Re: DD/2024/509 1-7 Bellevue Street, Glebe

The Glebe Society makes the recommendations set out below in respect of the application.

Figure 1 A survey of the roofing materials of the houses across the road from 1 -7 Bellevue Street.

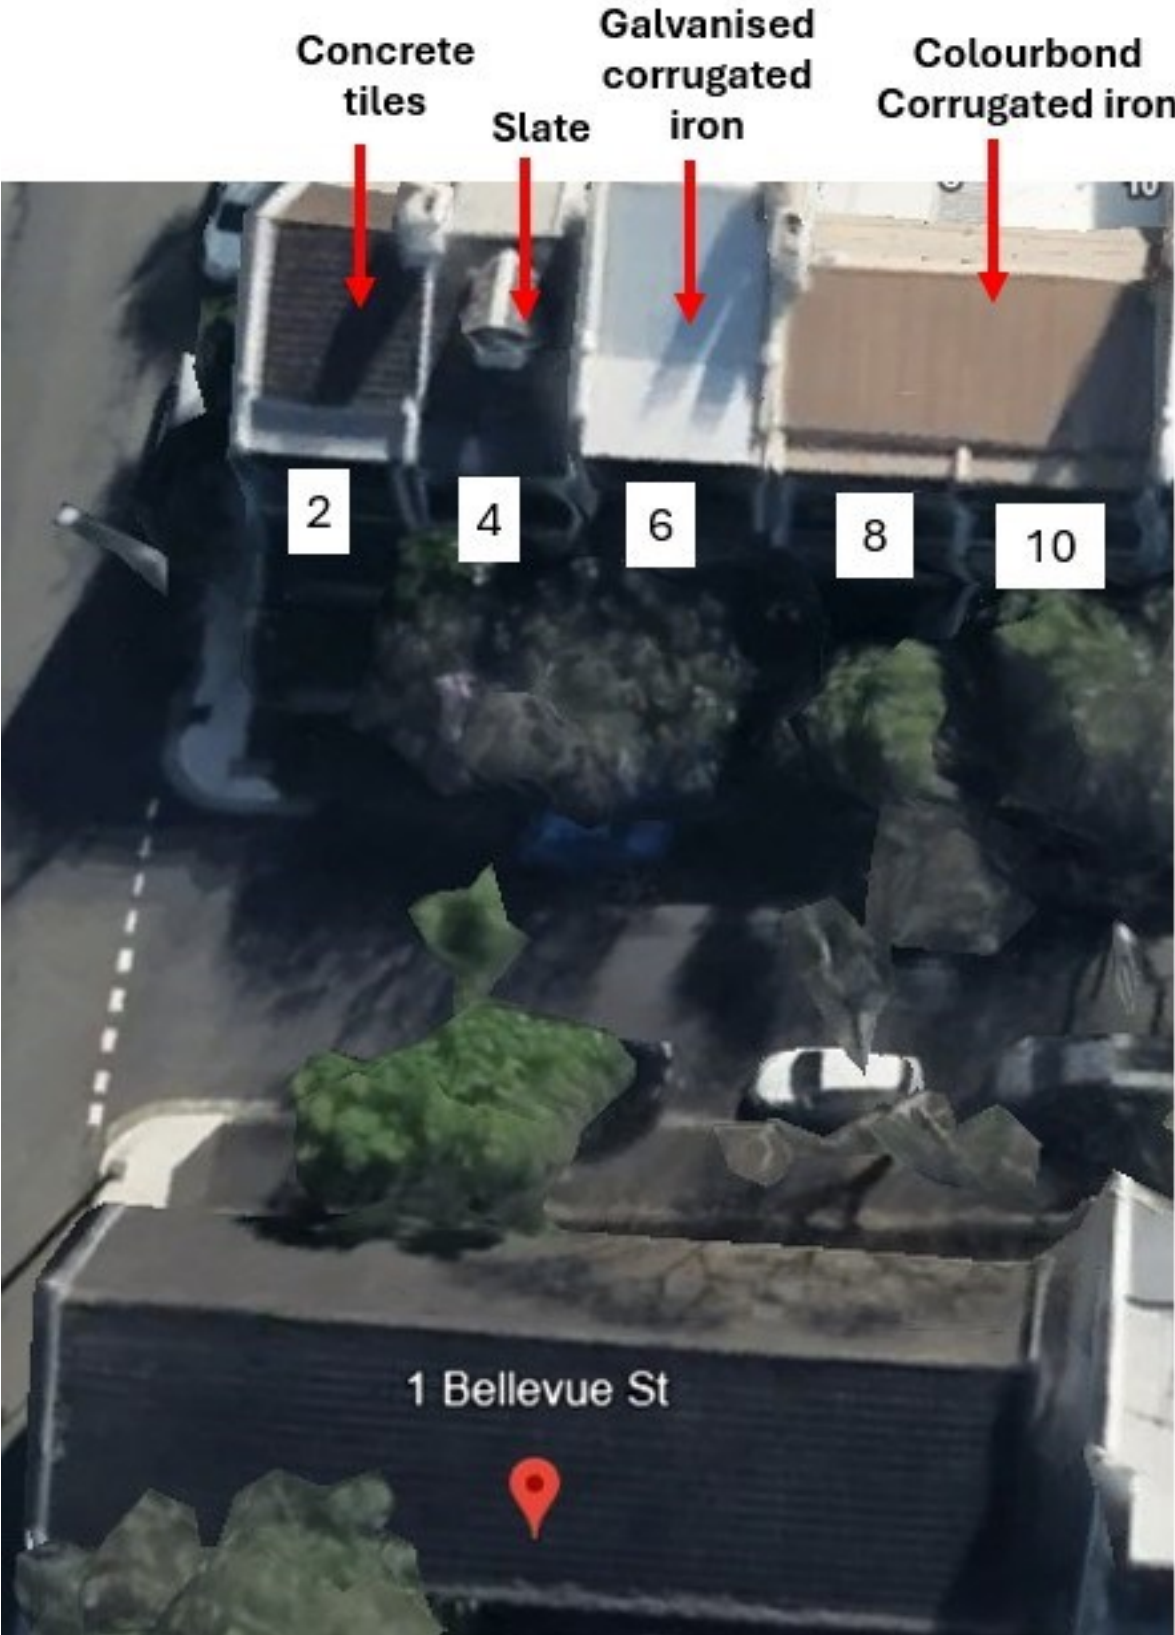
Originally the roof was slate. The concrete tiles are obtrusive. The proposal is to replace them with Colorbond standing seamed metal roofing. It is claimed that this would *be more sympathetic to the slate and corrugated metal roofs of the neighbouring properties.* It is not sympathetic and would be more obtrusive than the concrete tiles. The ideal would be to replace the concrete tiles with slate but if expense precludes this the roof should be replaced with galvanised corrugated steel roofing which is the contemporary equivalent of late 19<sup>th</sup> century galvanised corrugated iron.

Figure 1 below shows the roofing materials of the five houses facing the former St Ita's Church/School in Bellevue Street. Number four retains its original slate roof, number two (which was built as a pair with number four) has had its slate roof replaced with concrete tiles. number six is galvanised corrugated steel and numbers eight and ten are Colorbond corrugated steel. There is no seamed metal roofing here or in the neighbouring properties. Galvanised corrugated steel is preferred to Colorbond corrugated steel because it resembles a traditional material widely used in Glebe and does not fade as Colorbond roofing does. If colorbond corrugated steel is used it the colour selected should be as close as possible to the

colour of galvanised corrugated steel. This would be in accordance with the recommendation in the Lyndhurst Heritage Conservation Area Inventory Report to *encourage the recovery of the original character during renovations and building upgrade.*

1. Galvanised corrugated steel be used for the roof, or Colorbond corrugated steel of a colour which is similar to that of galvanised corrugated steel roofing, rather than the proposed colour bond standing seamed metal roofing
2. The existing door at D2 , its decorative gothic revival hinges and the transom above it to be retained
3. The porch on the eastern elevation be deleted

Figure 2 Door D2 is an original door which retains its elaborate Gothic revival hinges. The transom window above is also original

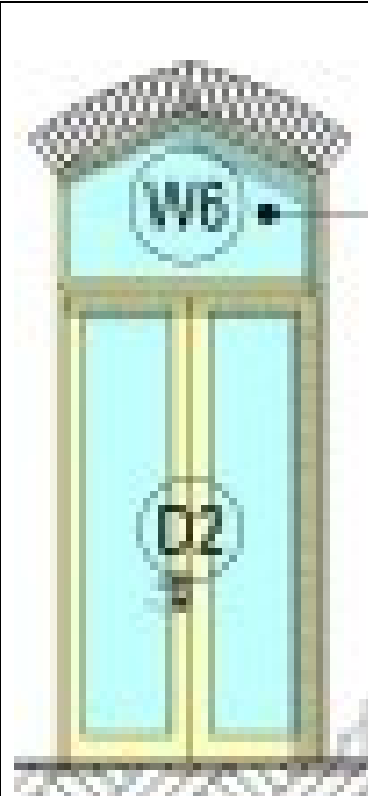
The proposal involves removing an original door with its decorative hinges and removing the original transom with its three glazing bars. This is contrary to the claim in the HIS that *no demolition of external fabric is proposed*. These elements are important and should all be retained.

Figure 3 The proposal is to remove both the transom, the door and the hinges

Figure 5 The original roof is very intact. The linings appear to be Baltic pine

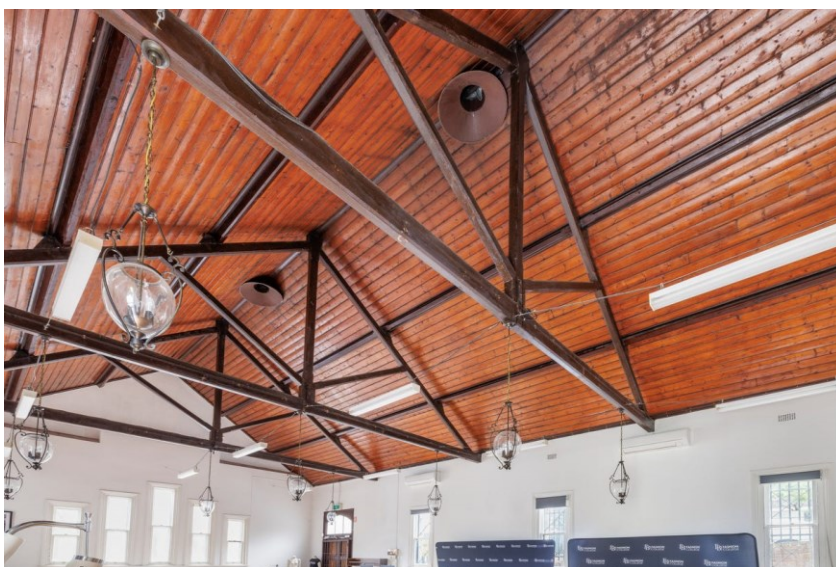
It is important to retain the existing roof, for its materials and structure and for the original volume of the space to continue to be legible.
